STAFF RECOMMENDATION

NCPC File No. MP060

ARMED FORCES RETIREMENT HOME
DRAFT MASTER PLAN
Rock Creek Church Road and Upshur Street, NW
Washington, D.C.

January 27, 2006

PROPOSED DEVELOPMENT ZONES

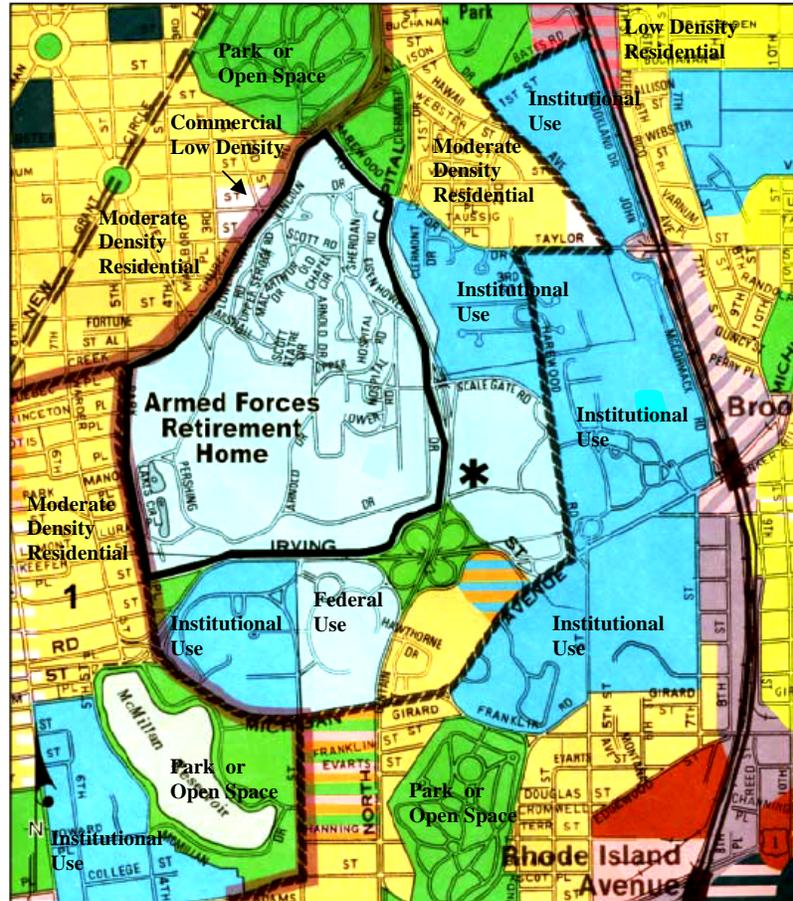
- Reduce the total amount of proposed development. The Commission does not support the applicant's proposal to develop as much as 9 million gross square feet of new space on the AFRH campus. The maximum total square footage of new development should not exceed the moderate range of new buildable space set forth in the master plan's draft environmental impact statement.
- Ensure that building heights are compatible with the character and scale of the surrounding area and consistent with comparable local zoning districts.
 - Staff's review of existing development in the surrounding area and of comparable zoning districts in the city indicates that building heights in Zones 3 and 4 should not exceed 65 feet, and a minimum open space buffer of between 50 and 100 feet should be maintained along the exterior boundaries of these zones.

- Revise maximum building heights in Zone 1A to ensure consistency with the plan's designation of this zone as suitable for "small structures" flanking "the green space in front of the Grant Building." Development guidelines currently indicate that there will be minimal development in Zone 1A but also state that new construction may be up to 55 feet in height, which exceeds the definition of "small structures." Revise and expand upon guidelines for new development in this area through the Section 106 consultation process.

- Revise maximum building heights in Zone 1B so that they do not exceed the height of the Sheridan Building.
- Limit new development in Zone 2 to Zone 2B, and minimize impacts to the existing tree canopy in Zones 2A and 2C.

- Submit a revised plan and development framework guidelines for Zones 5 and 6 that respond to comments received through consultation under the National Historic Preservation Act. To the extent practicable, conserve a portion of the area for use by the public for recreation, in accordance with the Comprehensive Plan for the National Capital. Preserve the viewsheds of the National Historic Landmark of the AFRH pursuant to the Secretary's standards and Section 110 of the National Historic Preservation Act, better define the historic attributes to be preserved, and specify the amount, location and nature of proposed open space in these zones.

- Revise proposed building heights in Zones 5 and 6 to bring them into conformance with surrounding zoning and development patterns, and increase proposed buffers to protect existing forested areas. The four- and eight-story development proposed would radically transform these zones and affect the setting of the National Historic Landmark to the north, the approach to that landmark area, and its viewsheds.

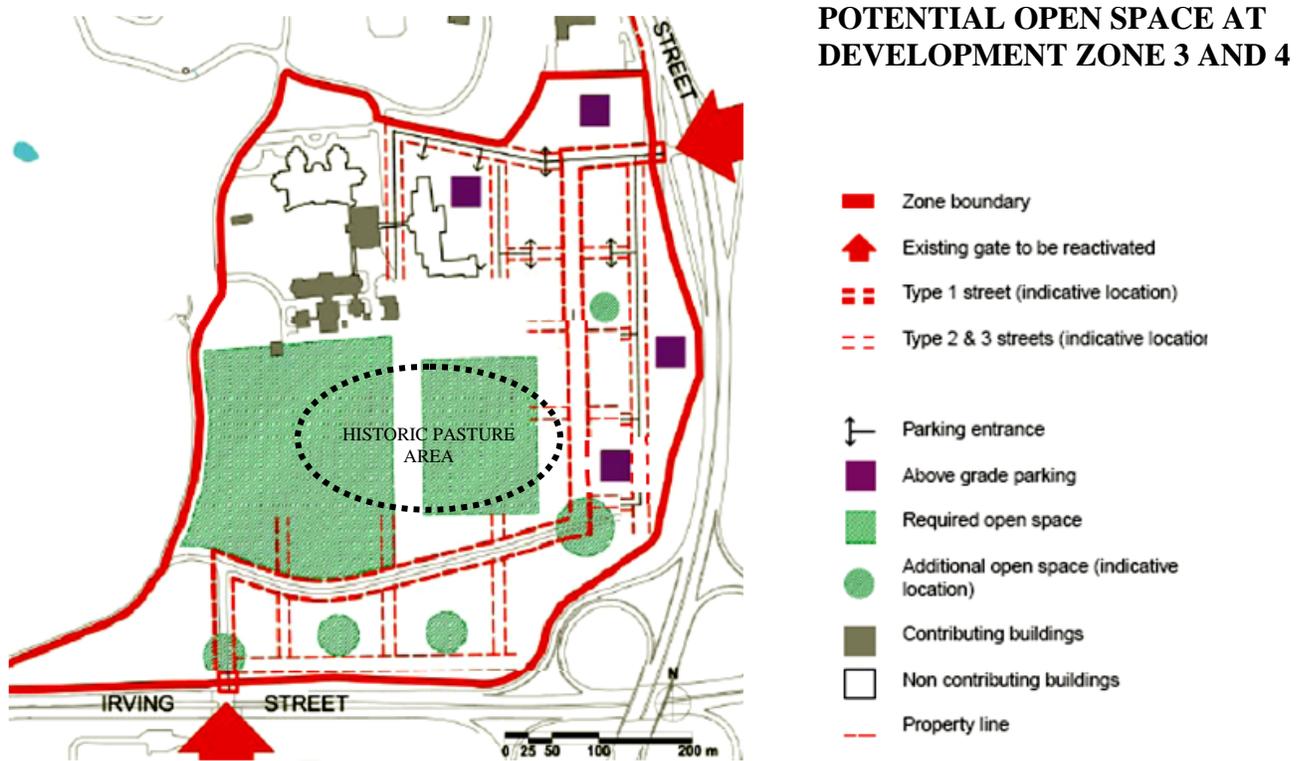
Much community focus on the proposed draft plan emphasizes the availability and access to recreational open space. The Comprehensive Plan refers specifically to AFRH in its policy stating that the federal government should “conserve portions of military reservations that add significantly to the inventory of park open space and natural areas and should, to the extent practicable, be used by the public for recreation.” Staff notes that guidelines for Zones 3 and 4, which include a portion of historic pasture area, call for open space to be created and/or maintained. (See diagram on page 17) However, the proximity of Zones 5 and 6 to residential neighborhoods and the historic and environmental sensitivity of those areas leads staff to find that public park areas should be provided in those zones as well.

Currently the entire AFRH site is secured and not open to the public. However, the relocation of the secured perimeter proposed in the submission provides an opportunity to achieve the open space goals established in the Comprehensive Plan. Thus, staff believes a more concerted effort must be achieved within Zones 3, 4, 5 and 6 to specify and highlight a recreational open space component to the plan, and clarify exactly a requirement that organized recreational space, coordinated with community input.

- Provide within the plan for Zones 3 and 4 a well-defined publicly accessible recreational open space component that reflects the input from NCPC staff and members of the local community.

DRAFT MASTER PLAN PROPOSED SECURED PERIMETER FOR THE AFRH COMMUNITY

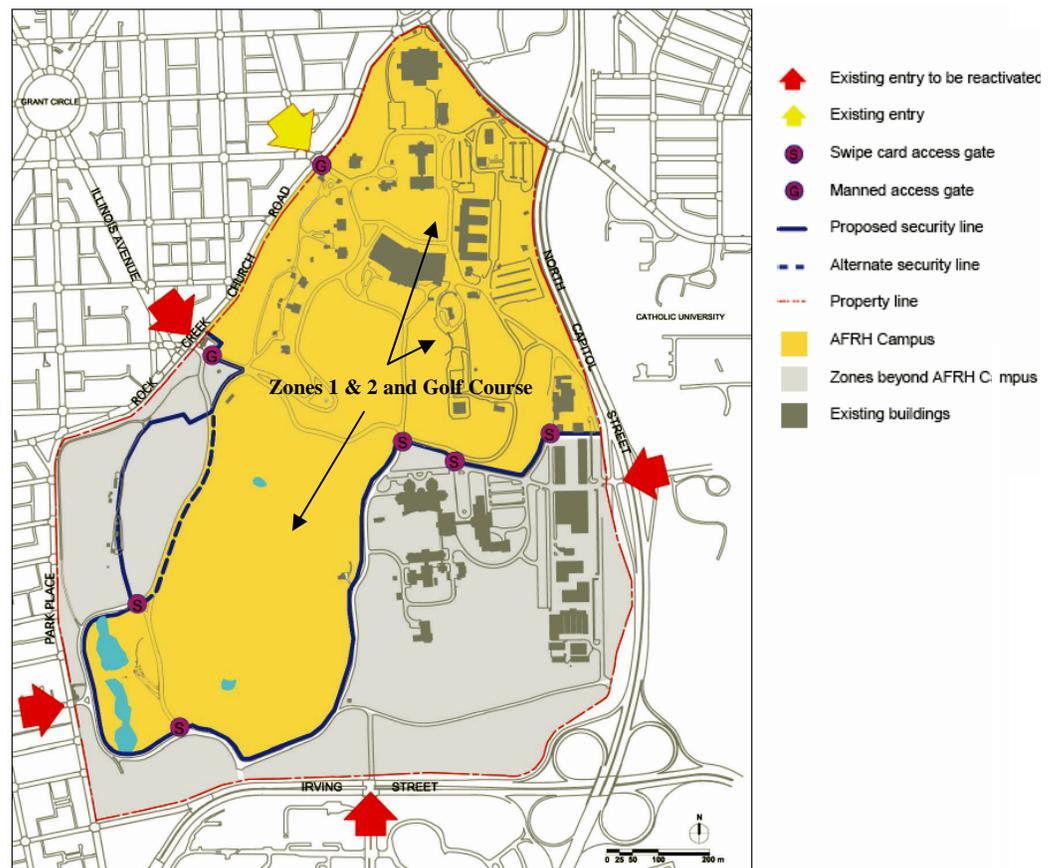
The impact of the physical security measures—a secure perimeter fence and controlled visitor access, is limited to the vehicle and pedestrian traffic entering only the AFRH Zones 1 and 2 and its surrounding recreational areas. In context with the nearby community, the whole of the AFRH existing campus was originally closed to the public in 1925. The proposed draft plan would now reduced the perimeter fence area of the Home and provide public access to Zones 3, 4, 5, and 6 as demonstrated in the diagram on page 18.
